UNITED STATES PATENT AND TRADEMARK OFFICE

10/817,235

Office Action Summary

DETAILED ACTION

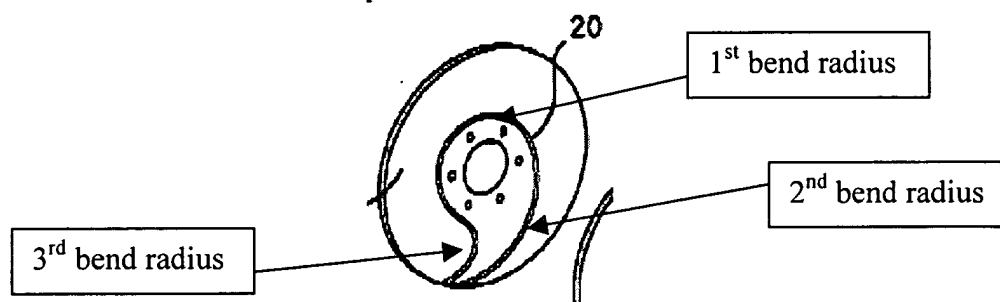
Referring to Applicant's prior art Figure 2, groove 20 has 3 different bend radii. Since Applicant has claimed each groove to have a different bend radius and groove 20 has 3 different bend radii, Applicant's prior art Figure 2 shows a plurality of connected grooves.

Applicant also argues the prior art relied upon by the Examiner fails to show a plurality of grooves on one flange. However, the Examiner disagrees. Applicant claims each groove on the single flange to have a different bend radius (R_i). Referring to Applicant’s prior art Figure 2 below, it can be seen that three different radii are on the single flange. Each radius is connected together creating three grooves, each with a different bend radius, all connected together.
